STAFF REPORT

Re: The Charleston – Site Plan Amendment Request

Application No.: APR-0087-2021

Project Location: Approximately 1229 E. Pioneer Rd.

EXHIBIT E
SITE GRADING AND DRAINAGE PLAN

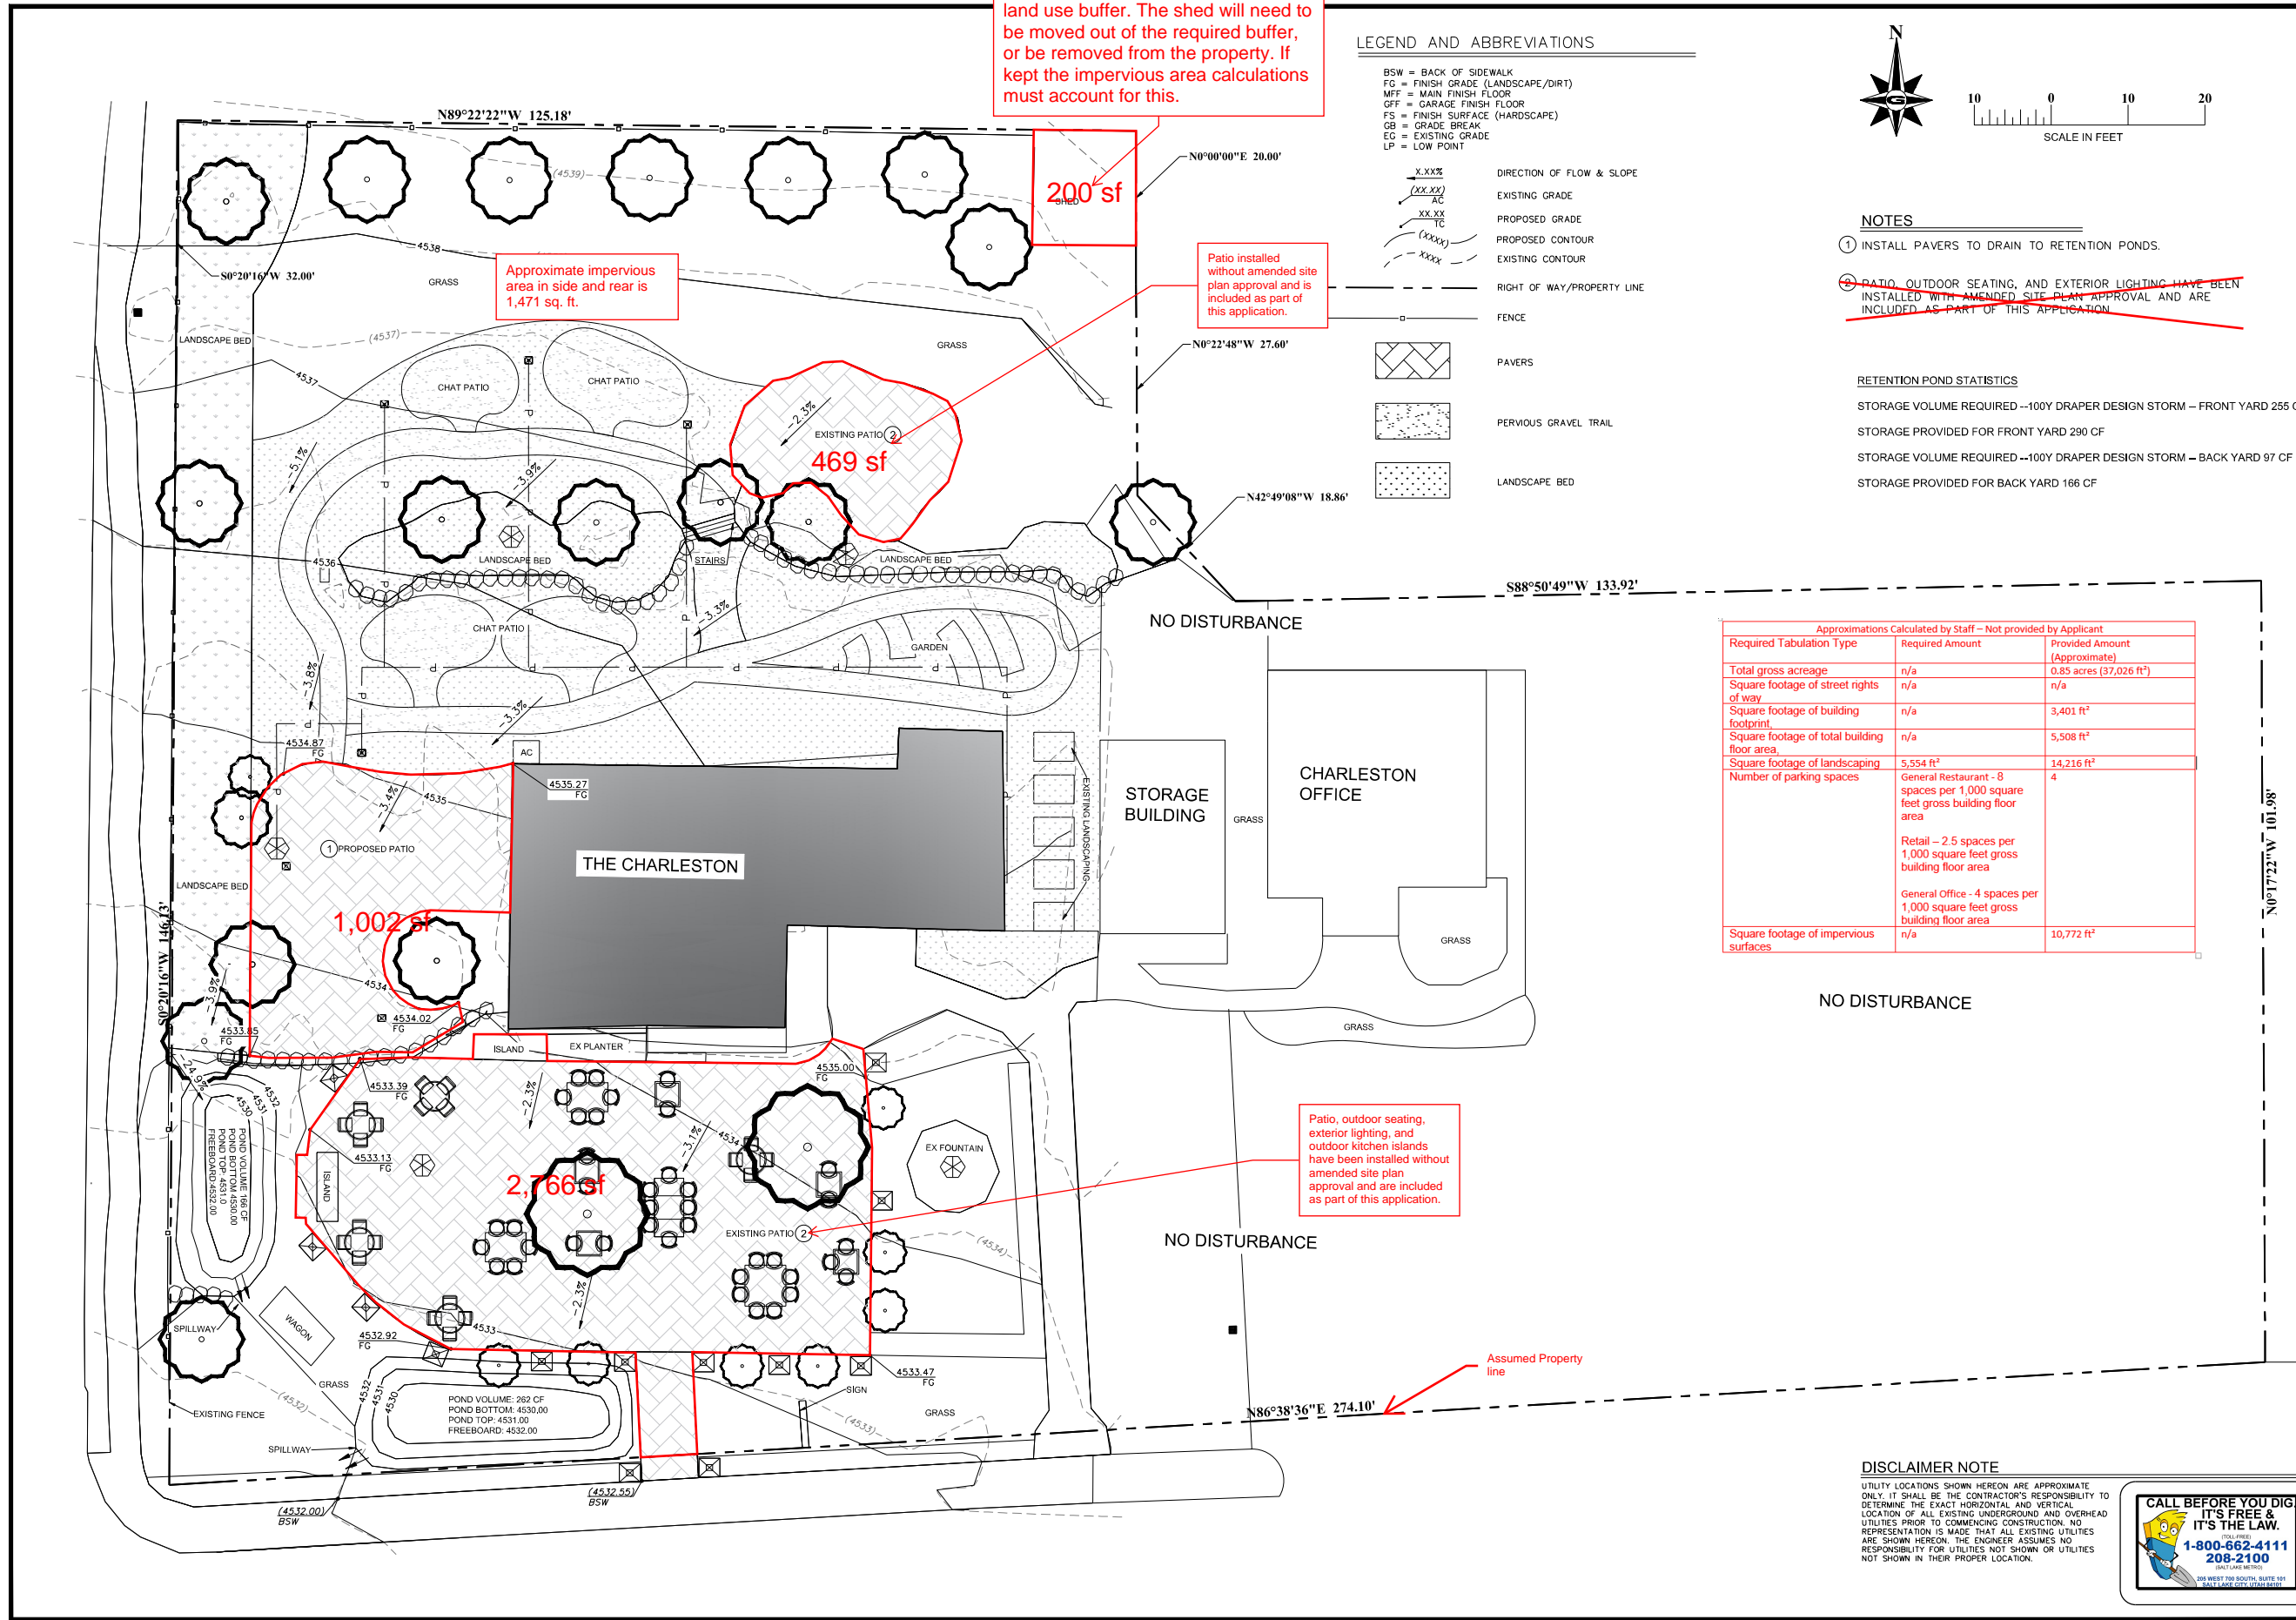
Shed was added to the property between 2017 and 2018 without required permits and approvals and may not be located in the required 20' land use buffer. The shed will need to be moved out of the required buffer, or be removed from the property. If kept the impervious area calculations must account for this.

Approximate impervious area in side and rear is 1,471 sq. ft.

Patio installed without amended site plan approval and is included as part of this application.

Patio, outdoor seating, exterior lighting, and outdoor kitchen islands have been installed without amended site plan approval and are included as part of this application.

EXHIBIT G
LANDSCAPE PLANS

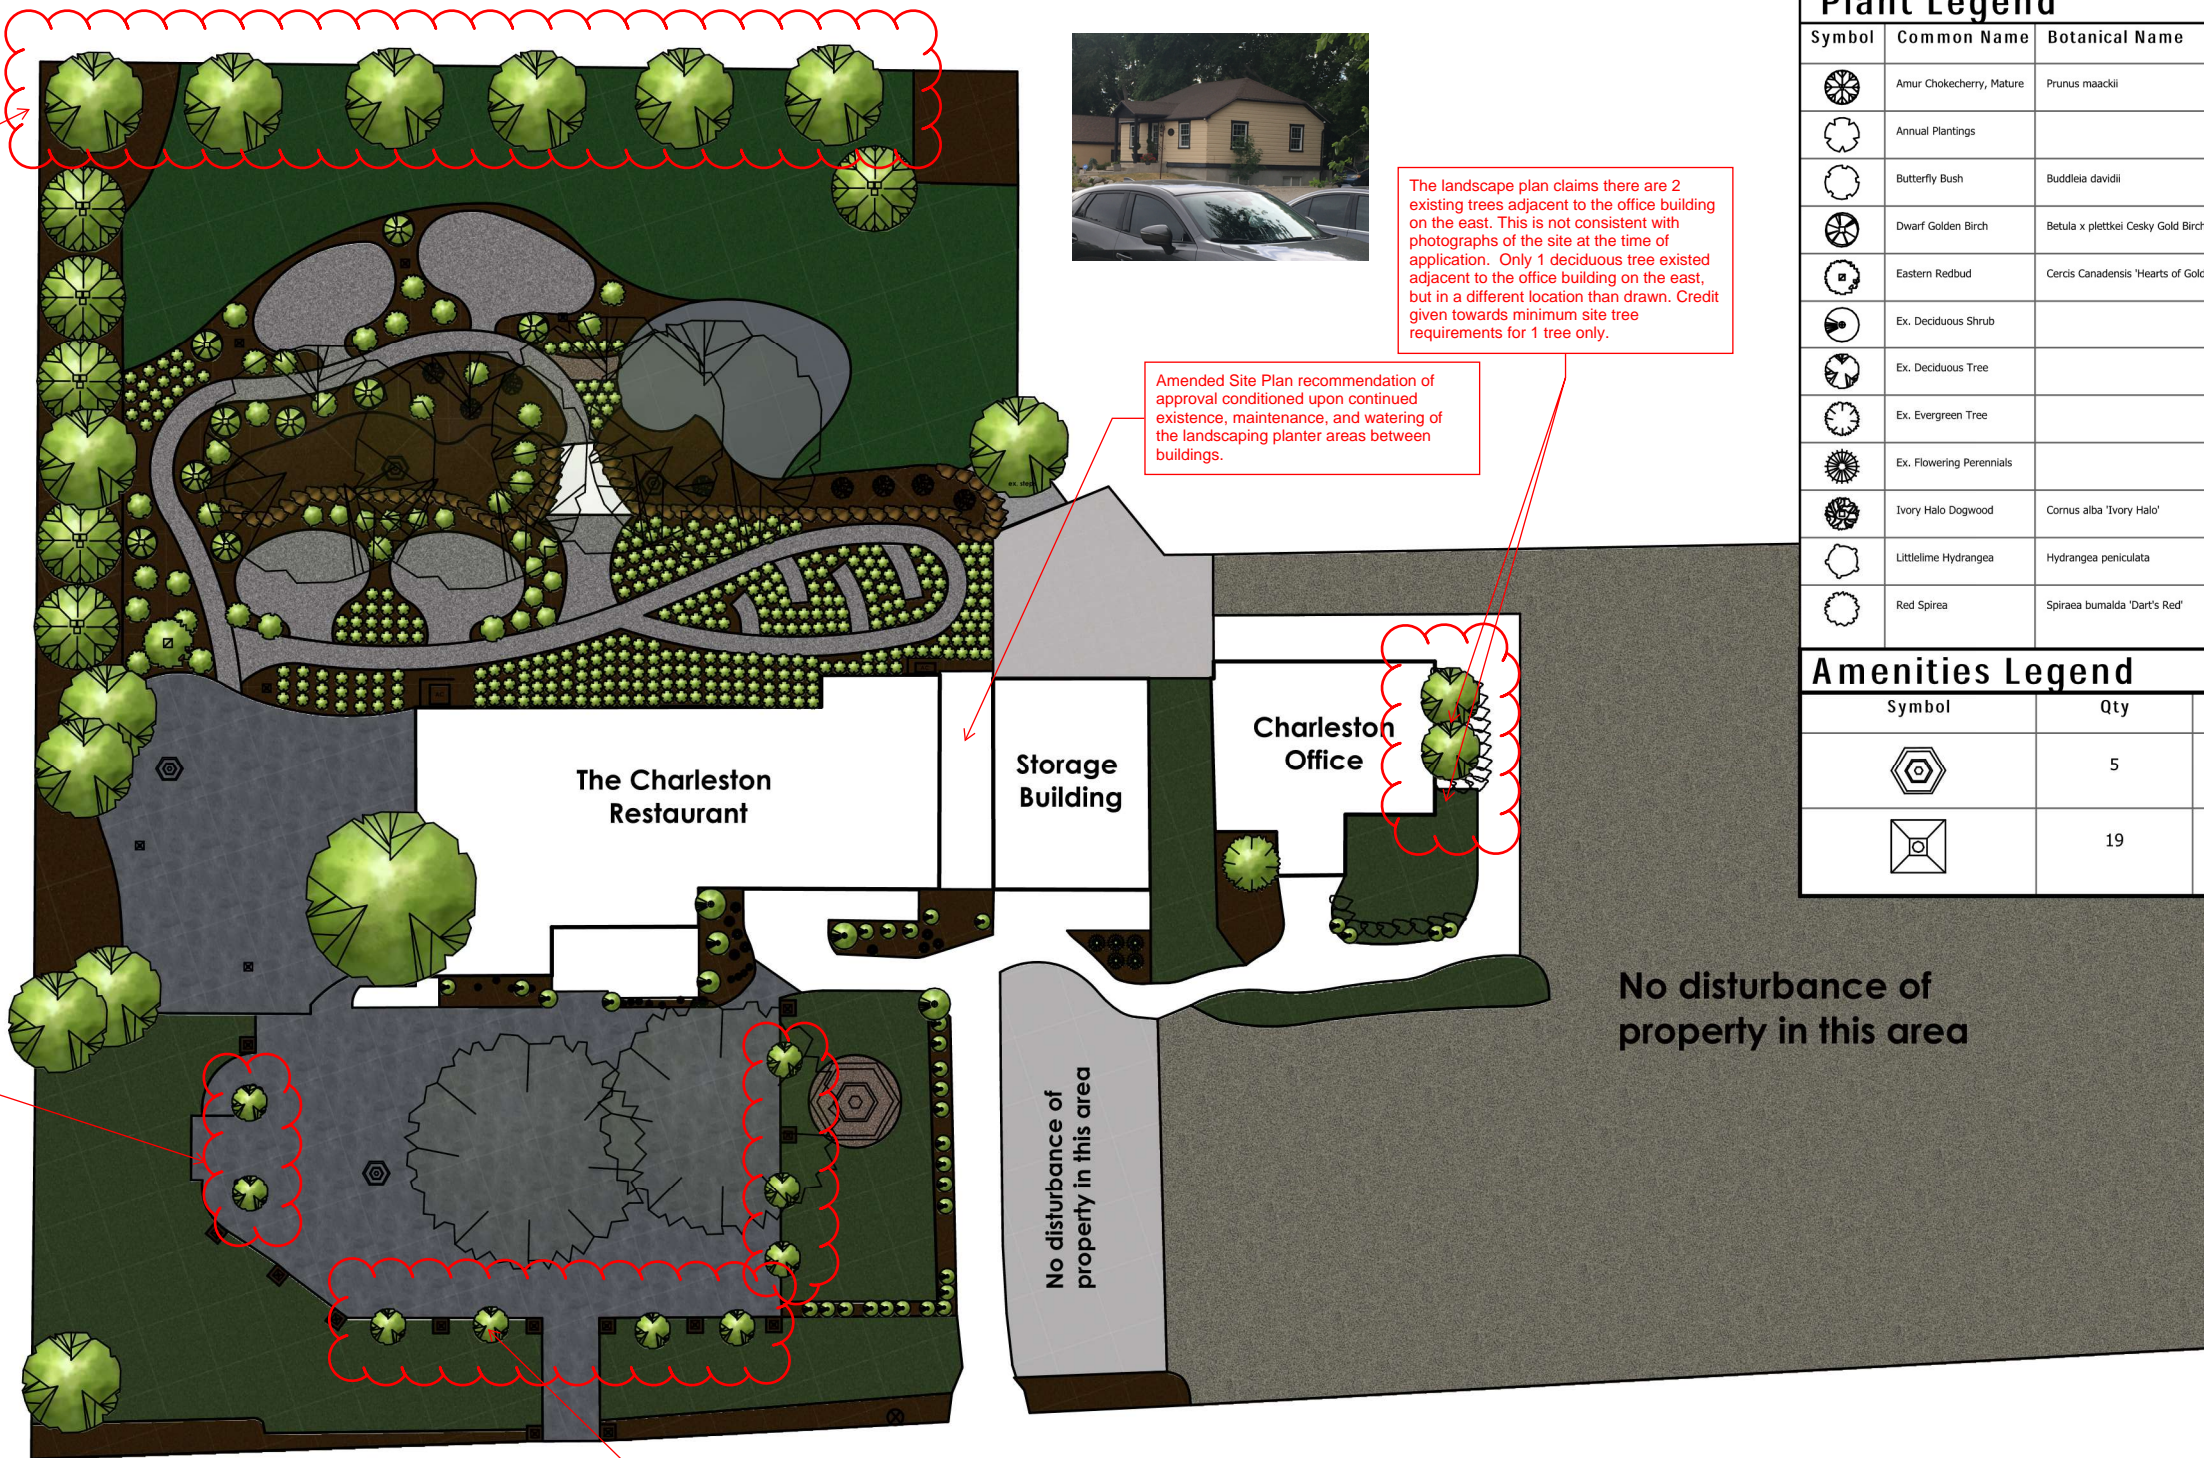
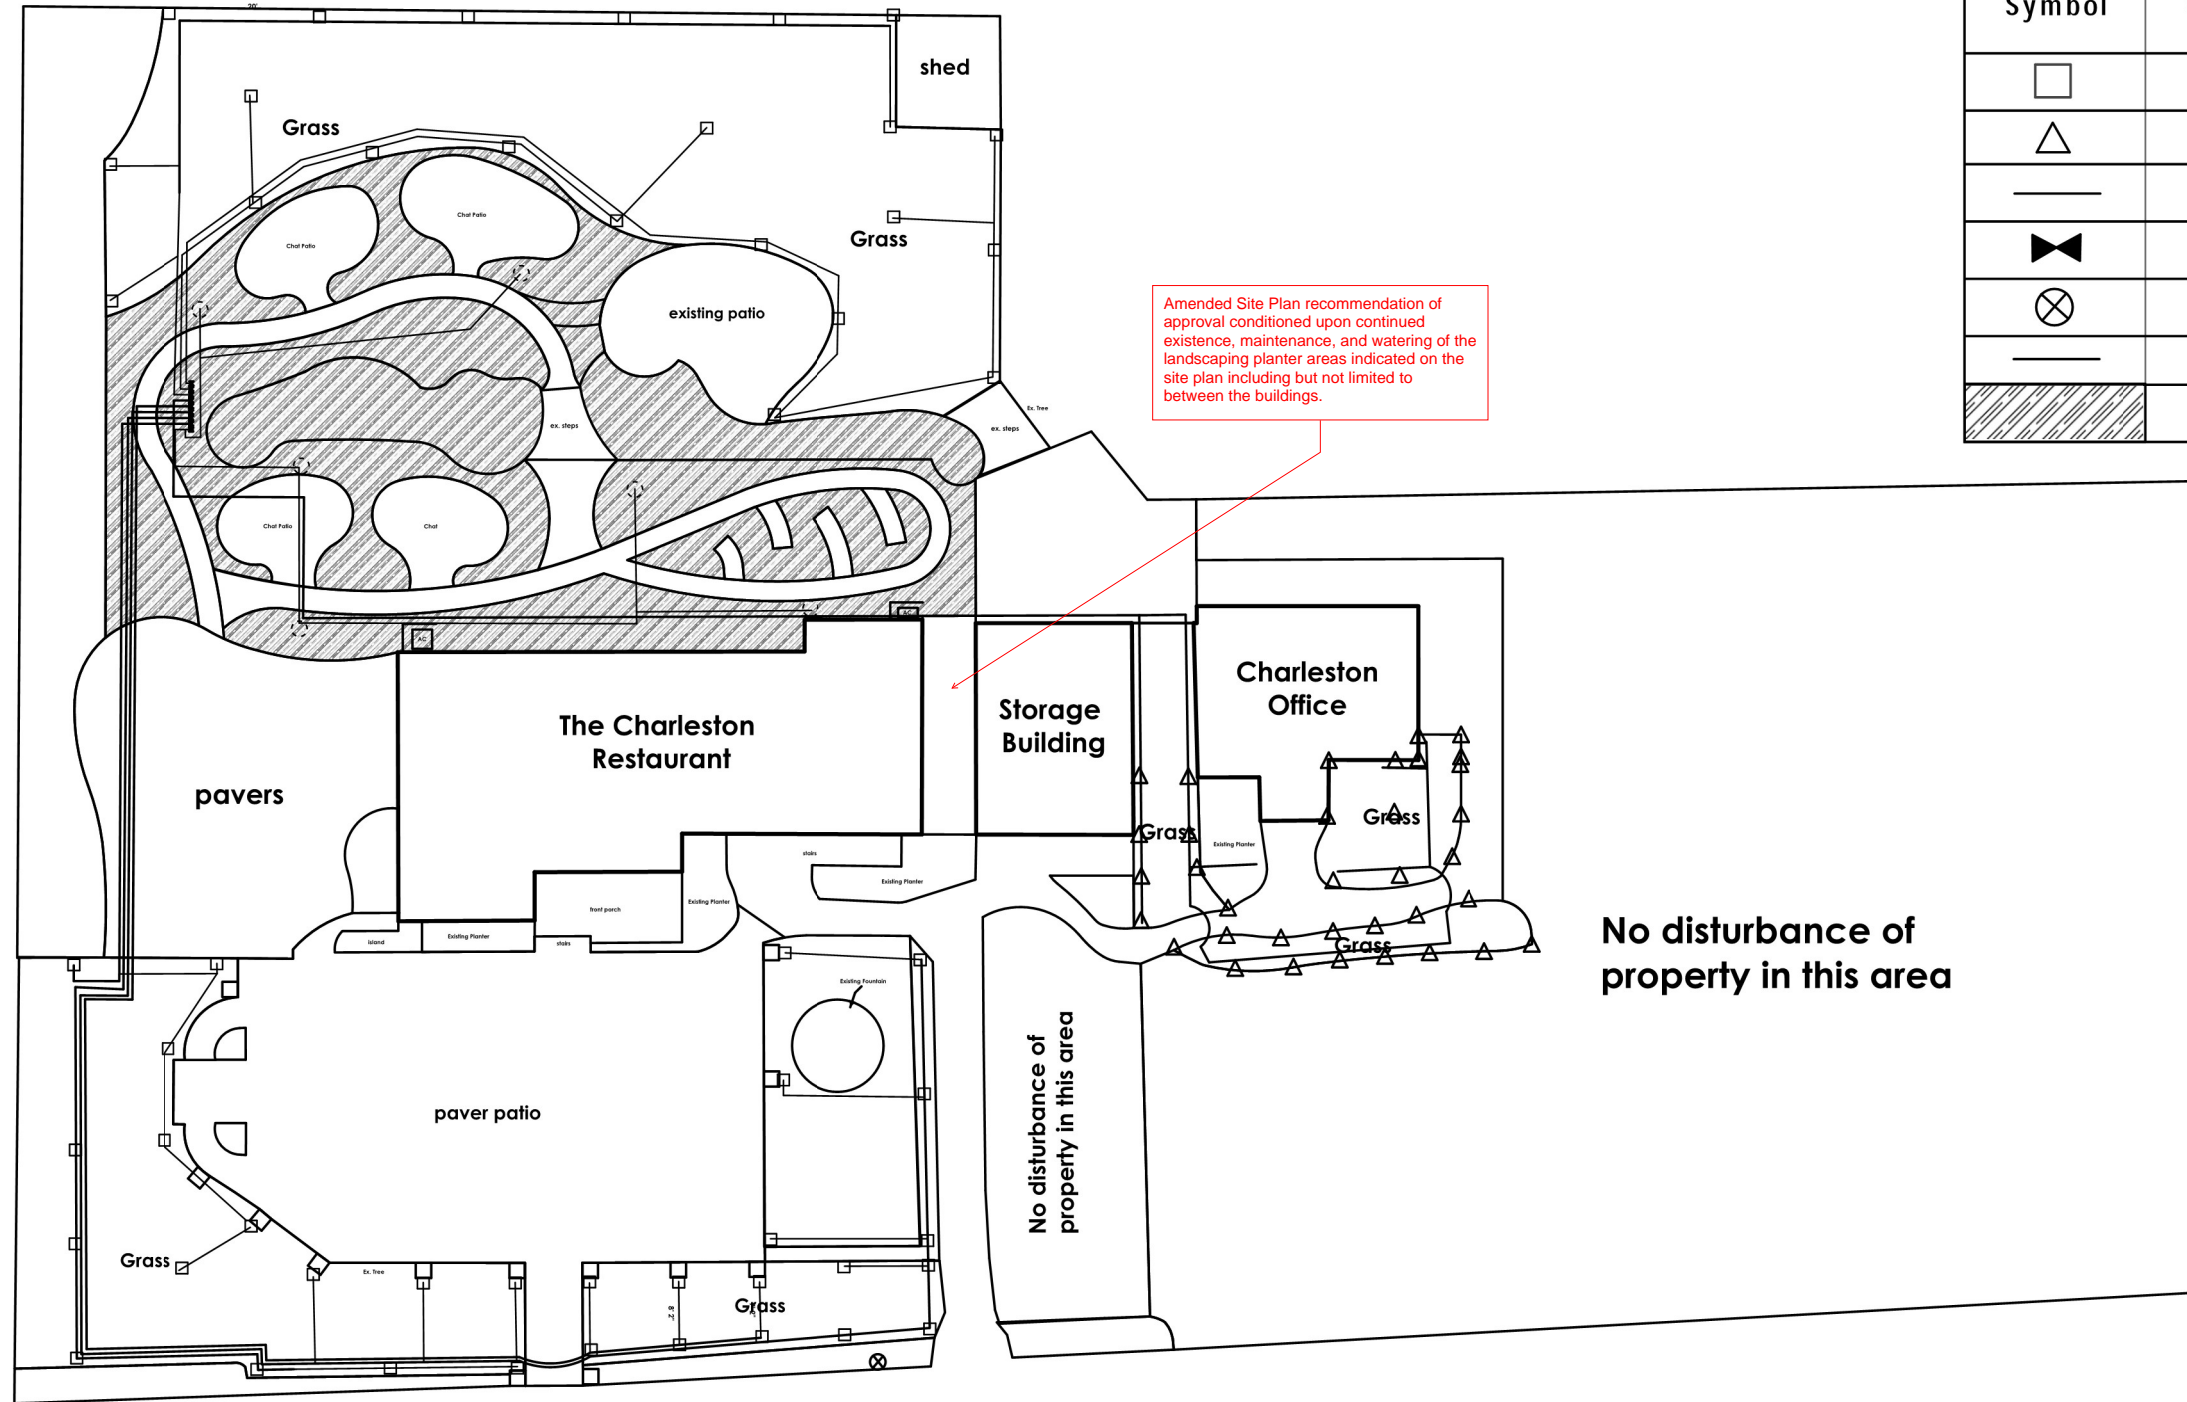
Photographic evidence does not corroborate the assertion of the landscaping planting plan that there are existing deciduous trees buffering between the subject property and the residential property to the north. Amended Site Plan recommendation of approval conditioned upon the installation of 6 deciduous shade trees of a minimum 2" caliper along the northernmost property line in the locations shown on the landscape planting plan, as well as all other plantings as shown.

The landscape plan claims there are 2 existing trees adjacent to the office building on the east. This is not consistent with photographs of the site at the time of application. Only 1 deciduous tree existed adjacent to the office building on the east, but in a different location than drawn. Credit given towards minimum site tree requirements for 1 tree only.

Amended Site Plan recommendation of approval conditioned upon continued existence, maintenance, and watering of the landscaping planter areas between buildings.

2 ornamental trees installed on the western end of the front patio do not meet minimum 6 foot height requirement and do not count towards minimum site tree requirements.

At least 14 of the deciduous trees claimed as existing trees were not in existence at the time of application. New deciduous shade trees shall be a minimum of 2" caliper at time of planting. Ornamental trees and evergreen trees shall have a minimum height of 6 feet at time of planting. 36 trees meeting minimum size requirements are required, 16 existing trees are accounted for. Amended Site Plan recommendation of approval conditioned upon installation of the remaining 20 trees as indicated on the red-lined Planting Plan.

7 deciduous trees shown as surrounding the front patio on the landscape planting plan did not exist at the time of the application. Amended Site Plan recommendation of approval conditioned upon the installation of 7 deciduous shade trees of a minimum 2" caliper, or 7 ornamental trees of a minimum 6' height are planted in the locations shown on the landscape planting plan. Trees planted in movable planters will not be counted towards the minimum site tree requirements.
